**Flood Control Project Maintenance  
Levee Inspections**

## Maintenance Issue Types Only, Levee Inspection Report By Mile - Spring 2019

### Merced Streams Group

Waterway	Bank	Unit Miles	Inspection Start/End	Inspector
Unit No. 01 Black Rascal Diversion	Right	1.61	04/30/2019 04/30/2019	Corey Fujitani

Photo 1 of 3 : UCIP\_SP\_2019\_50155\_35642.jpg

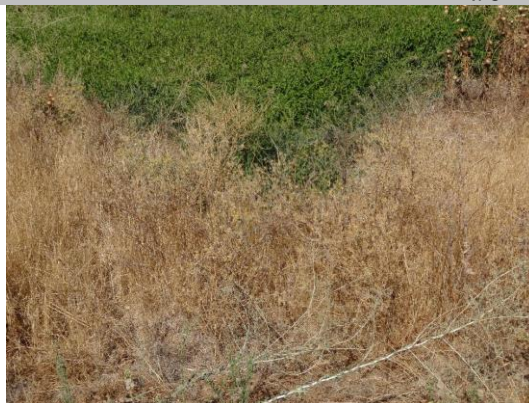
Comment Code					
Inspector Comment					
FS_ID:50155 DS_ID:23072 EP_NO: N/A Repair Type: Non-Urgent Crossing Status: Found UCIP Comments: 09/29/2016: WS cleared by NA0013. Crossing will be downgraded from Non-Urgent to No Action Needed upon receipt of photo showing cleared LS inlet. (K. Fazel - UCIP)09/2013:- needs vegetation clearing on both levee sides. (P. Amatya - UCIP) FIELD_STRUCT_DESC: 24-inch corrugated metal gravity drainage pipe through the levee, 6 feet below the crown. Concrete headwall, flap gate, and concrete grouted cobble spillway on the waterside (WS) toe. Concrete headwall on the landside (LS) toe. [Additional Reference(s): DWR Levee Log, 2005. USACE San Joaquin O&M Manual 607, June 1962, (HLM 0.58)]. FS Date: 9/7/2016

WS view: Dense vegetation on levee slope and spillway.
